Technical Note 4: 2nd Response to Camden Cycle Campaign

Site: Tavis House, Tavistock Road
Prepared by: GR/PdeJ
Approved by: PdeJ
Date: 9th March 2022

Figure 2.1 – Updated Ground Floor layout – Extract from Camden transport response document

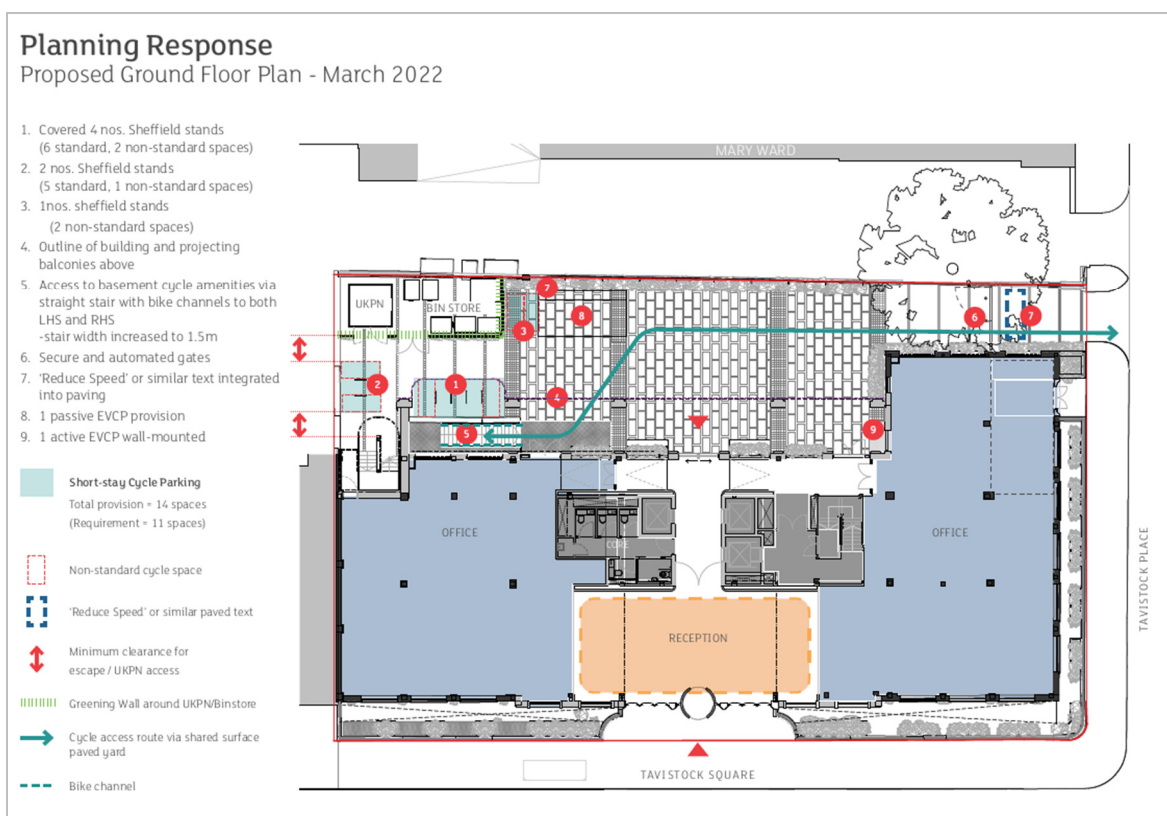
"They appear to have reduced the amount of ground floor cycle parking from 18 to 14 to give space for non-standard cycles but their updated ground floor plan shows space for only 3 non-standard cycles whereas their text (section 2.4) states that they will provide 6 (which is what the planning guidance of 5% requires).

In reply to my question about access to the basement cycle store they appear to rule out use of a lift. In the Transport Statement Appendix I (Travel Plan) section 4.11 page 17 they state "The long-stay cycle parking spaces will be provided in the basement in a dedicated cycle store with access via goods lift located at the rear of the service bay (see Figure 4.1)". But in the response they state that "There will be no mechanical ramp or lift provided" and "A straight stair with bike channel will be in place to allow for ease of access to the basement cycle store." This discriminates against people who use a conventional bike but have balance issues or lack upper-body strength. Access via a lift should be provided for people in this category.

In summary - I do not find the response acceptable in terms of (a) amount of parking for non-standard cycles and (b) access to the basement cycle store."

- 2.3 The updated arrangement provides a total of 6 no. non-standard cycle parking spaces further to changes to the layout at ground level. Two of the non-standards spaces (wider Sheffield stands) will provide secure, undercover long-term cycle parking and be available for employee cycle parking (long-stay), particularly for those cyclists who are less able and would prefer not to access the basement cycle store via the dedicated stairway. Short-stay parking for both standard and non-standard cycles will also be provided at ground level for visitors. Employees and visitors who are less able, will be able to park cycles on the site without the need to access the basement but can access the cycle facilities/shower easily via the main lifts/core to the basement accessed directly from the rear yard.

- 2.4 The revised layout provides the full complement of non-standard (6) spaces which will be available for either long-term or short-term parking. It may be noted that the visitor cycle parking provision exceeds the London plan requirement by providing 14 cycle parking spaces (11 short-stay spaces required).

- 2.5 The proposed stairway design has been carefully considered within the limitations of the existing building structure. The proposals are a refurbishment utilising lightwells and building heights and therefore the inclusion of a lift is not possible within the existing constraints. The width of the stairway will be increased to 1500mm and will connect the external yard to the rear of the building and the basement area. The stairway will be straight with a mid-landing, constructed with a favourable gradient being Part M compliant and will be suitable for access with a cycle. The stairway will be provided with an additional standard cycle wheel channel further to consultation in March 2022 to offer one channel on either side of the stairs to facilitate cycle movement between basement and ground floor from either the left or the right side of the cycle.

- 2.6 As mentioned in paragraph 2.4 of the response dated 9th February, there will be no mechanical cycle ramp or lift provided with the development and any less able cyclists will be able to park their cycles in a secure and covered location at ground level.
